CONNECT NORTHGLENN

BICYCLE AND PEDESTRIAN MASTER PLAN

APPENDICES

APPENDIX A: BICYCLE AND PEDESTRIAN SUITABILITY ANALYSIS METHODS

Figure H.5. Poor curb ramp design (Image Source: nacto.org)

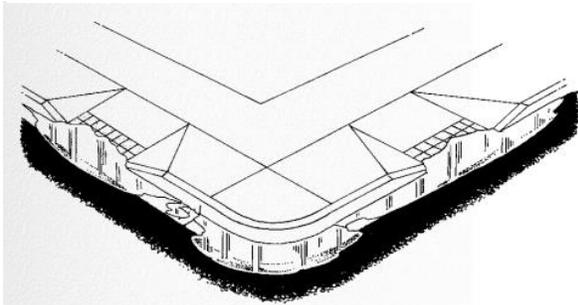
Adequate drainage upstream and downstream of the curb ramp will ensure that pooling does not occur here (See figure 7-42). This change is recommended to improve access and comfort for those with physical disabilities and/or using mobility assistance devices (i.e., wheelchairs, canes, walkers), which will only deteriorate further once the roadway is resurfaced and material at its edge is built up. It also helps to prevent ice formation and water ponding, which can also pose safety hazards.

Figure 7-42. POTENTIAL PROBLEM: Curb ramps that are susceptible to pond formation are inconvenient and unsafe (especially when water freezes) for all sidewalk users.

Figure H.6. Good curb ramp design (Image Source: nacto.org)

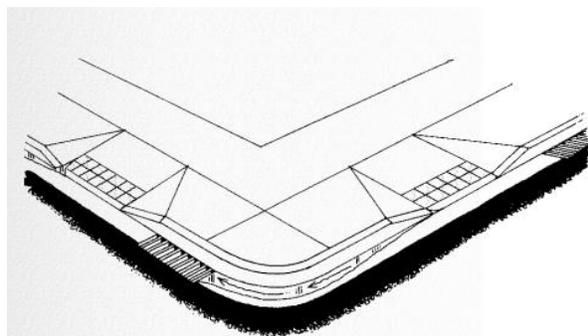
Figure 7-43. GOOD DESIGN: Locating drainage inlets uphill from curb ramps prevents puddles and debris from blocking the path of travel.

Figure H.8. Parallel curb ramps (Image Source: nacto.org)

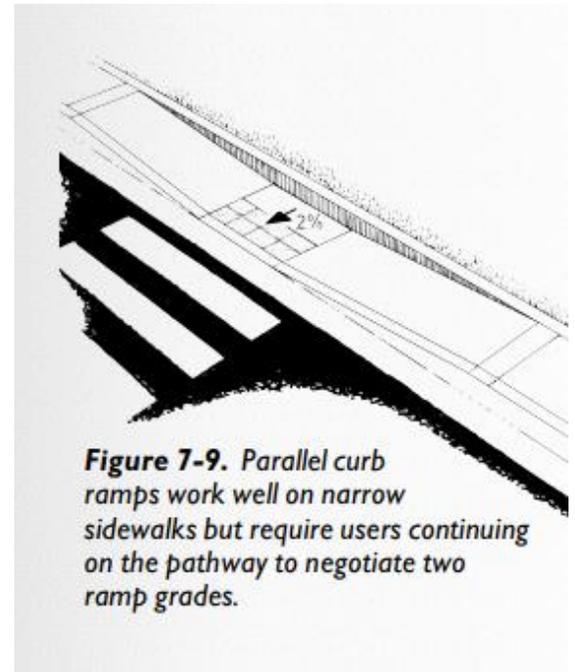
The top drawing on this sheet does not reflect the preferred curb ramp design for attached sidewalks. This drawing, and others, should be revised following the guidance provided by the Federal Highway Administration's (FHWA) "Designing Sidewalks and Trails for Access, Part II of II: Best Practices Design Guide". Figure 7-9 from that Guide may be particularly helpful for the revision of Drawing No. R9.⁵

In addition, it is recommended that any lip between the gutter and the ramp, but especially a 1" lip, be removed. Drainage improvements upstream and downstream may be required to prevent pooling at the bottom of the ramp.
